STAFF REPORT

SUBJECT: Bordeaux Estates
H-2022-0062

Annexation of two (2) acres of land with an R-8 zoning district; and combined preliminary & final plat consisting of four (4) building lots and one (1) common lot on 2.22-acres of land in the R-8 zoning district for Bordeaux Estates Subdivision.

C. Final Plat (dated: 4/20/2023) **REVISED**

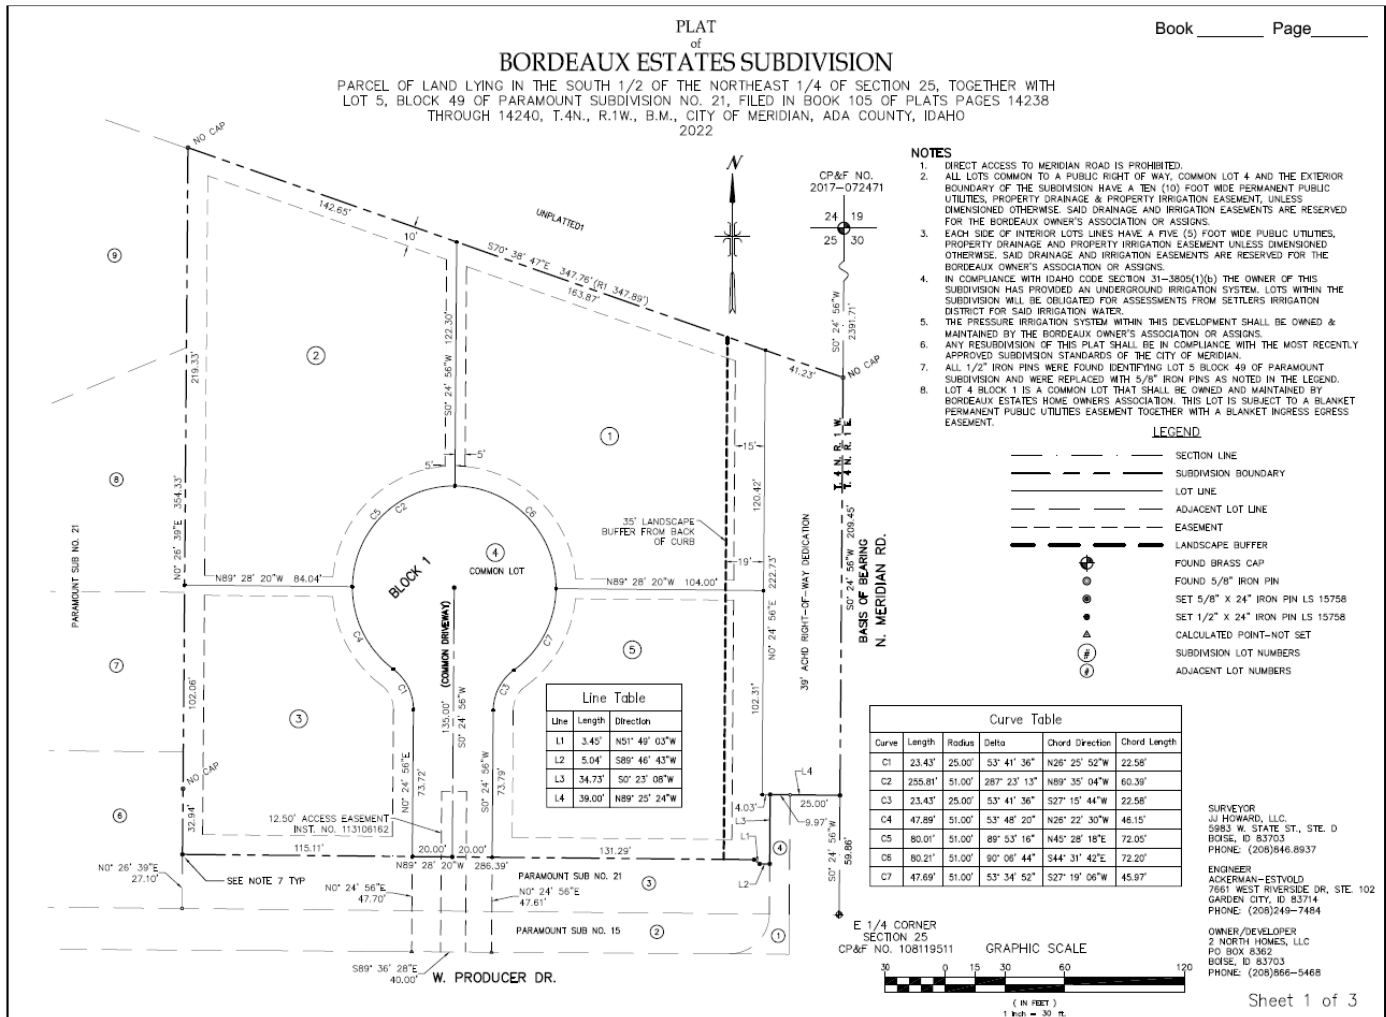
nonconforming structure as defined in UDC [11-1A-1](#). **The symbols for the “adjacent lot line” and the “easement” appear to be the same on the final plat; change one of them to another symbol.**

Landscaping (UDC [11-3B](#)): A 25-foot wide street buffer is depicted on the plat along N. Meridian Rd. The buffer is required to be widened to 35-feet in accord with UDC Table [11-2A-6](#) as Meridian Rd. is classified as an entryway corridor; the buffer should be landscaped in accord with the standards listed in UDC [11-3B-7C](#). Additional landscape design features are required within landscape buffers along entryway corridors per the standards in UDC [11-3B-7C.3f](#). The proposed buffer incorporates a 3:1 berm with a boulder wall at the back edge of the buffer at a maximum height of 3-feet. Alternative compliance may be requested to the width of the street buffer as set forth in UDC [11-3B-7C.1c](#); however, a reduction to the buffer width shall not affect building setbacks – all structures shall be set back from the property line a minimum of the buffer width required in the district (except for nonconforming structures).

Sidewalks ([11-3A-17](#)): Five-foot wide detached sidewalks are typically required within street buffers along arterial streets. **However, because ACHD is changing policy to require detached 10-foot wide**

pathways along arterial streets in lieu of on-street bike lanes for safety reasons, Staff recommends a 10-foot wide sidewalk is required as a provision of the development agreement.

2. The final plat submitted for City Engineer signature shall include the following revisions:
 - a. Depict a 35-foot wide street buffer along N. Meridian Rd., an entryway corridor, per UDC [Table 11-2A-6](#), in a permanent dedicated buffer or a common lot. The buffer shall be measured from the ultimate curb location as anticipated by ACHD.

- b. Depict a 10-foot wide detached sidewalk within the street buffer along N. Meridian Rd. with an average minimum separation of greater than four (4) feet to back of curb.

- c. Note #8: Modify the blanket ingress-egress easement to include the requirement for maintenance of a paved surface capable of supporting fire vehicles and equipment; or, submit a copy of a separate recorded easement as noted below in condition #5.

- d. Depict the location of the ingress-egress easement over Lot 2, Block 49, Paramount Sub. No. 15 and Lot 3, Block 49, Paramount Sub. No. 21 and include the recorded instrument number of the easement.

- e. The symbols for the “adjacent lot line” and the “easement” appear to be the same on the final plat; change one of them to another symbol.

D. Common Driveway Exhibit – REVISED

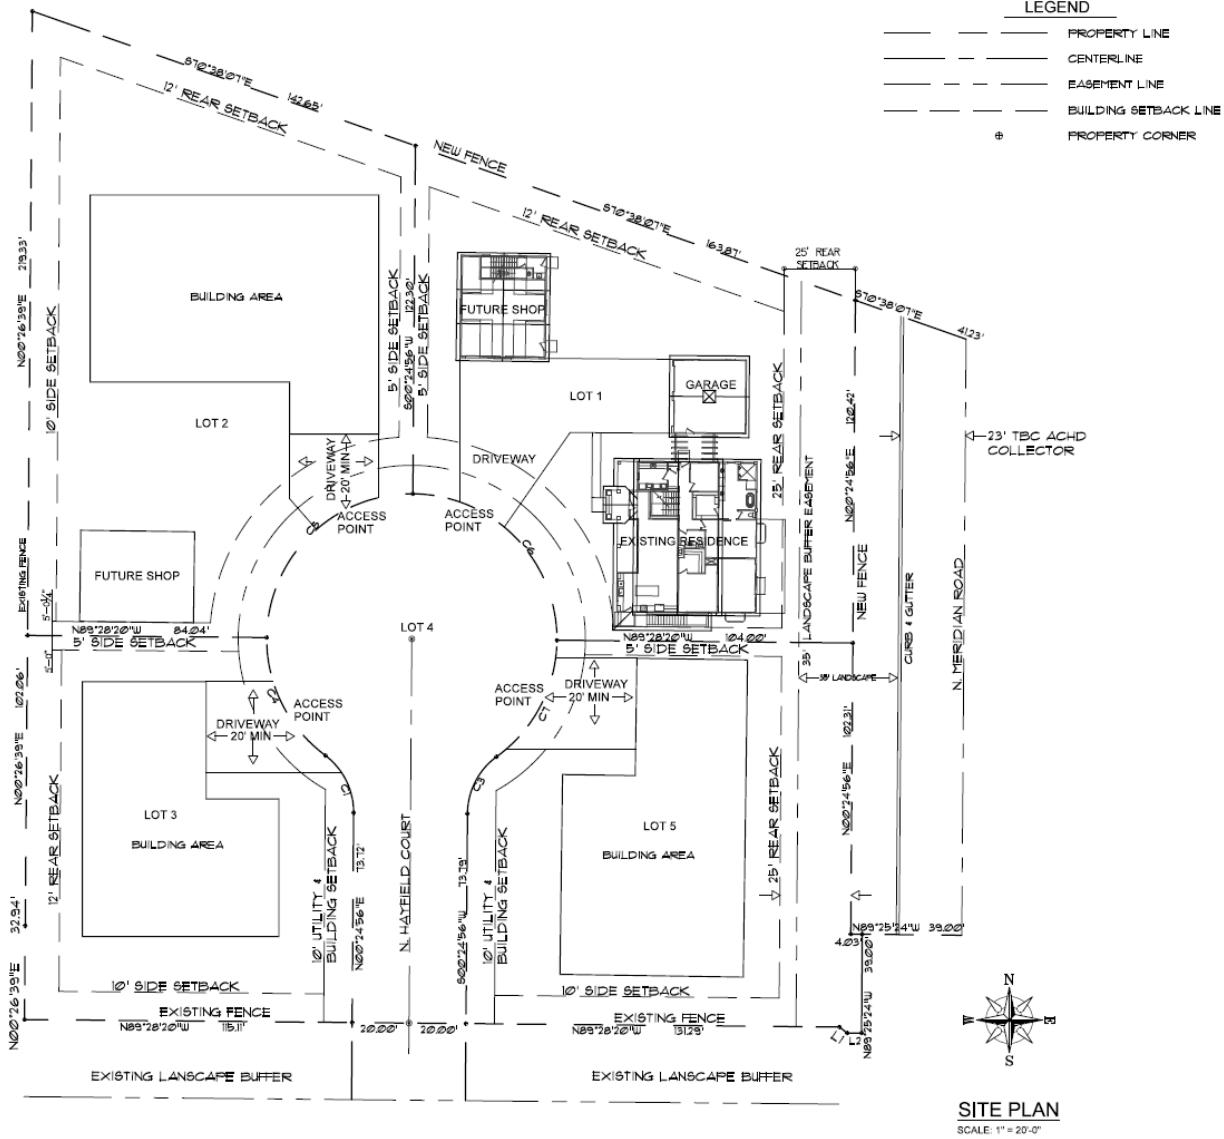
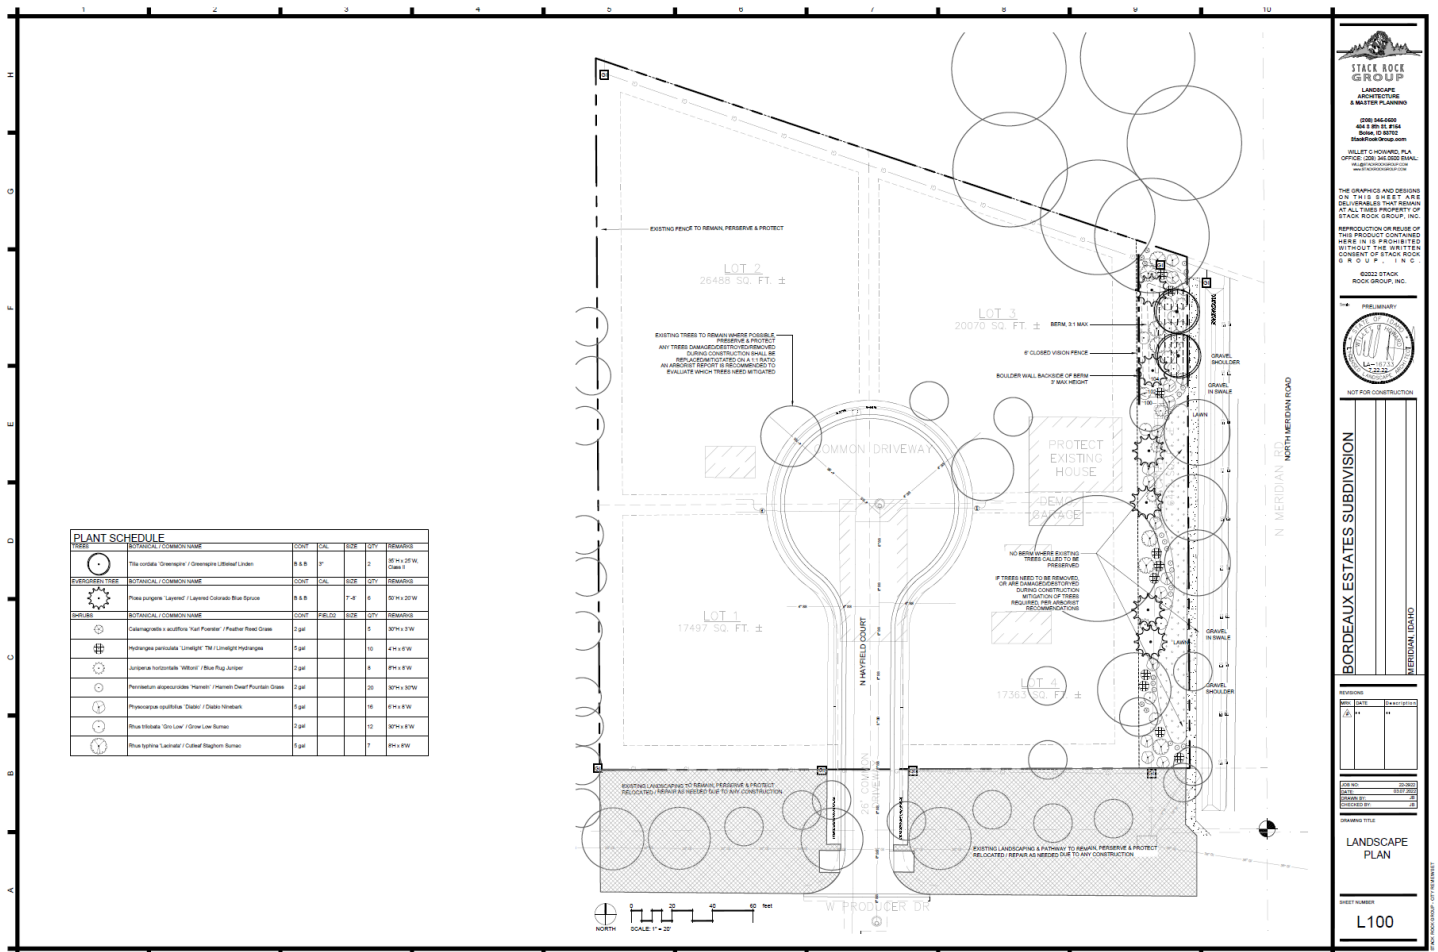
Access: Access is proposed via a common driveway from W. Producer Dr., a residential collector street adjacent to the southern boundary of this site. A revised common driveway exhibit was submitted as shown in Section VIII.C that complies with the standards listed in UDC [11-6C-3D](#); however, the setbacks for Lots 1 and 2 depicted on the exhibit do not all comply with the minimum setbacks for the R-8 district and a 35-foot wide landscape buffer is required, not a 25-foot wide buffer. The exhibit should be revised prior to the Council hearing to reflect compliance with the dimensional standards [i.e. the north side of Lot 2 should be the rear setback and the west side should be the side setback; the existing home appears to encroach within the rear and possibly the (south) side setback; the street buffer needs to be widened to 35 feet; and the fence along Meridian Rd. (if proposed) needs to be placed on the interior edge of the street buffer].

- d. Depict fencing (if proposed) at the interior edge of the street buffer along N. Meridian Rd.
4. The common driveway shall comply with the standards listed in UDC [11-6C-3D](#) and the common driveway exhibit in Section VIII.D.

Lot 1 Existing House/ Remodel and Addition

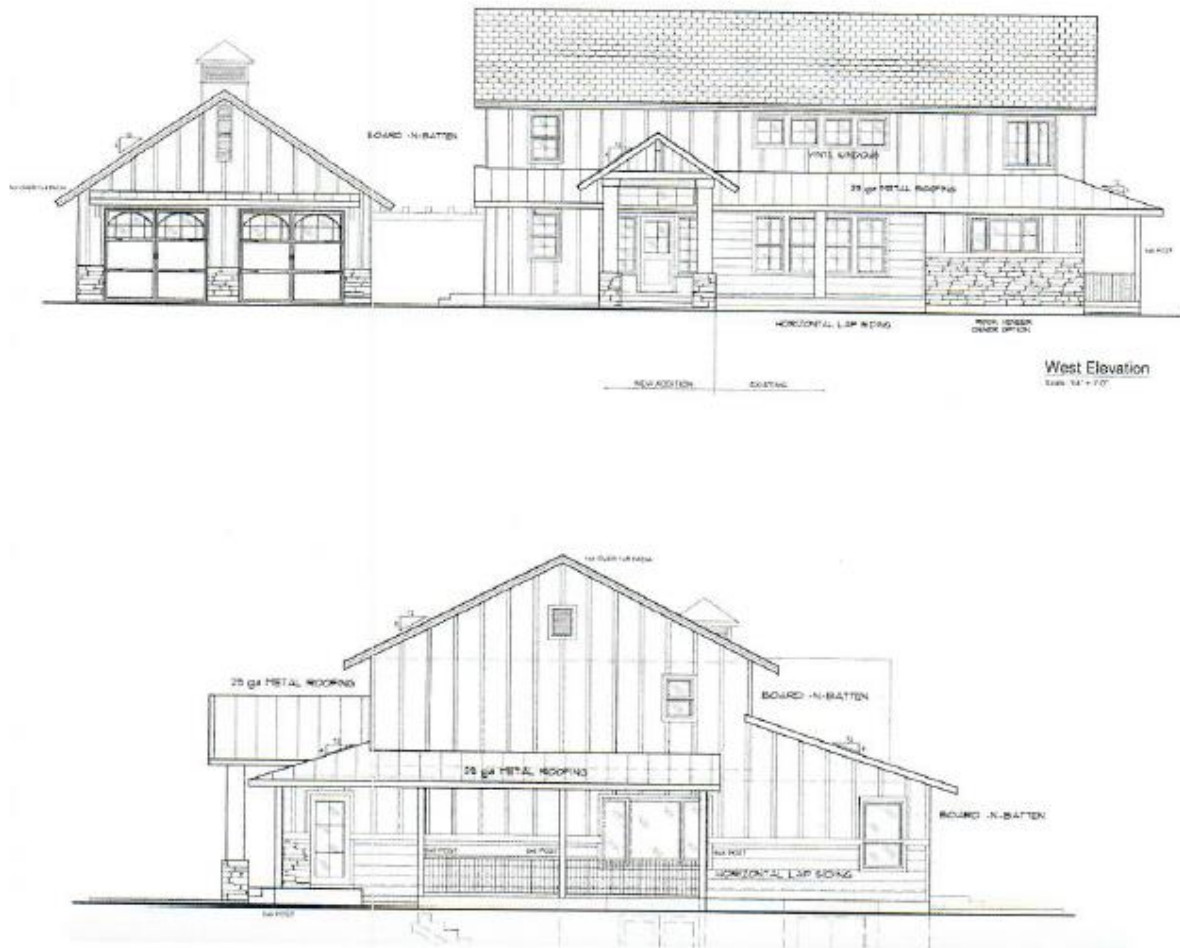
Building Elevations: One (1) conceptual building elevation for Lots 2, 3 and 5 and one (1) conceptual elevation of the remodeled existing home on Lot 1 with a new addition and detached garage in a modern farmhouse design was submitted as shown in Section VIII.F. Building materials consist of hardi or LP board & batten siding mixed with 8" lap siding, merril stone and natural wood accents, and architectural asphalt shingles with standing seam metal roof accents. Design review is not required for single-family detached structures. However, because the rear and/or sides of homes facing N. Meridian Rd. and W. Producer Dr. will be highly visible, those elevations should incorporate articulation through changes in two or more of the following: modulation (e.g. projections, recesses, step-backs, pop-outs), bays, banding, porches, balconies, material types, or other integrated architectural elements to break up monotonous wall planes and roof lines that are visible from adjacent public streets.

- f. The rear and/or sides of homes facing N. Meridian Rd. and W. Producer Dr. shall incorporate articulation through changes in two or more of the following: modulation (e.g. projections, recesses, step-backs, pop-outs), bays, banding, porches, balconies, material types, or other integrated architectural elements to break up monotonous wall planes and roof lines that are visible from the subject public streets.
